Product Change Notification

Change Notification #: 113294-00 - 00
Change Title: Intel® Server System R1304BB4DC
PCN 113294-00, Product Design
Update the System Rear Panel, Add a Mylar
and a Plastic Block

Date of Publication: October 13, 2014

Figure 1

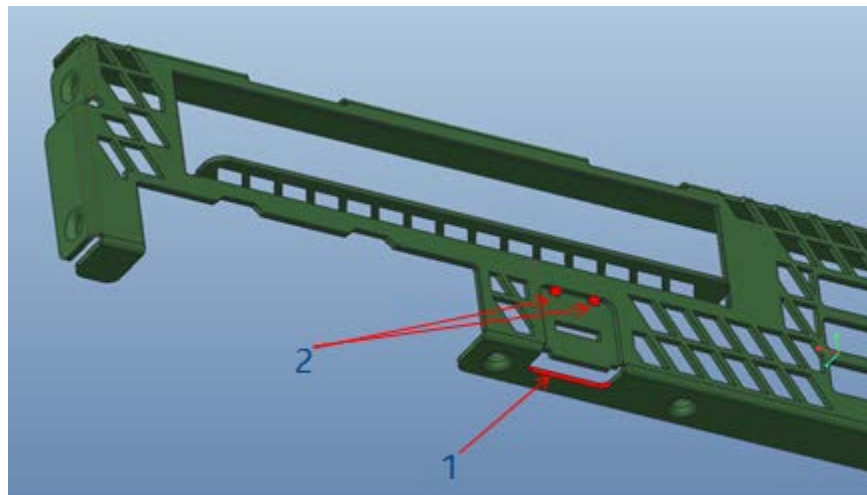
1. Add a connection at the bottom of the RMM4 (Remote Management Module 4) slot to improve structure strength. See item 1 in Figure 1.
2. Update the one big center joint to two smaller joints so that the joints will not conflict with the LAN cable connector latch. See item 2 in Figure 1.

Figure 3

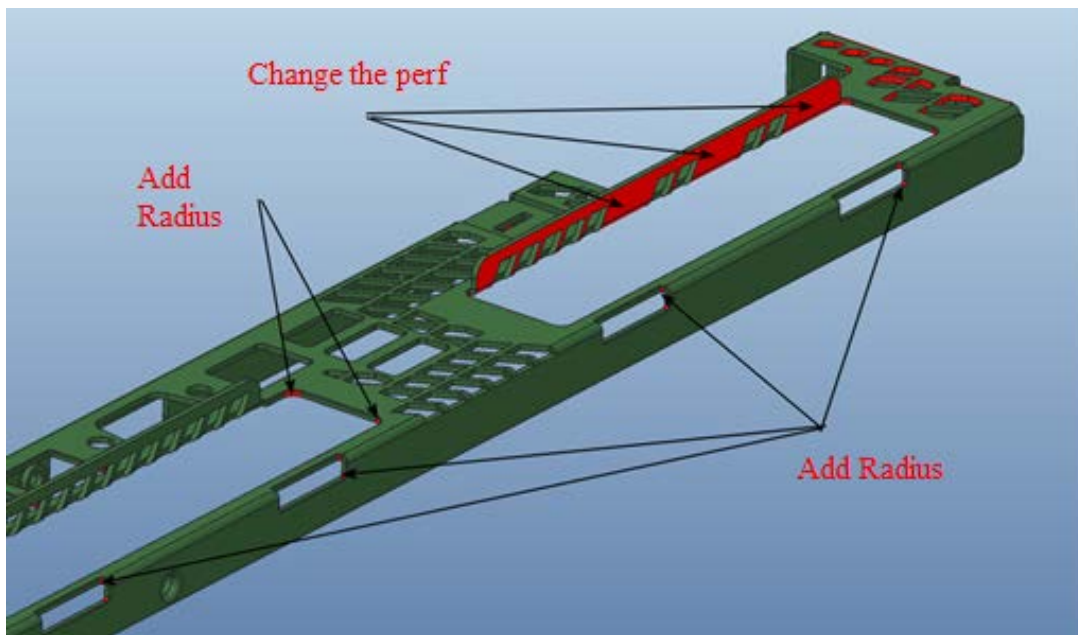
4. Update the perf and add radius to improve structure strength. See Figure 3 and 4.

Figure 5

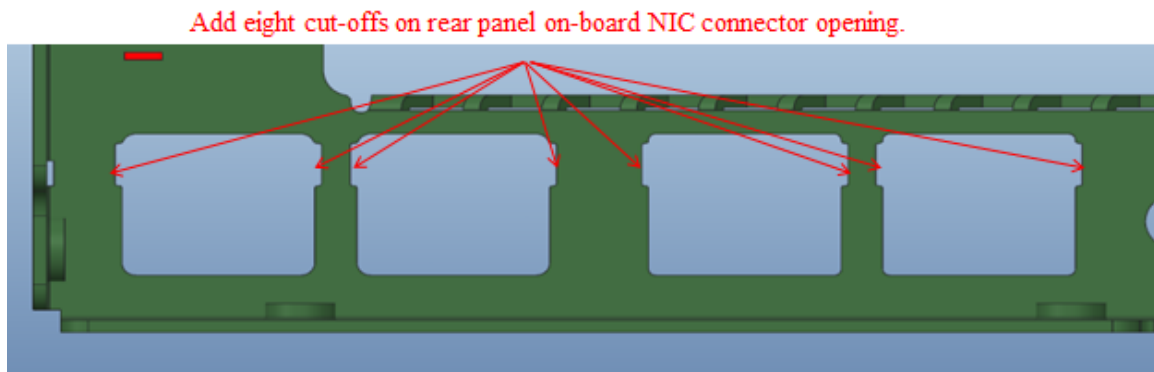
5. Add eight cut-offs around the on-board NIC (Network Interface Controller) openings to improve the LED visibility. See Figure 5.

Figure 6

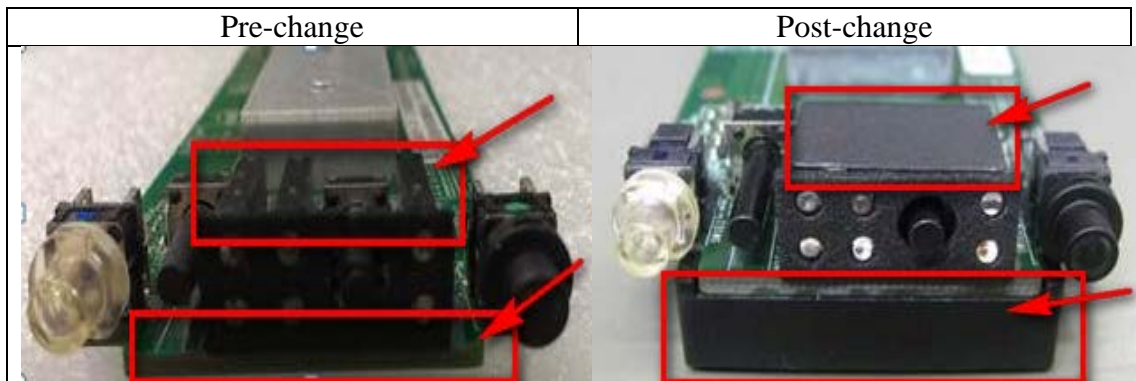
6. Add a mylar on the top of the front panel board and add a plastic block for the front end under the front panel board to hold parts more securely. See the images below:
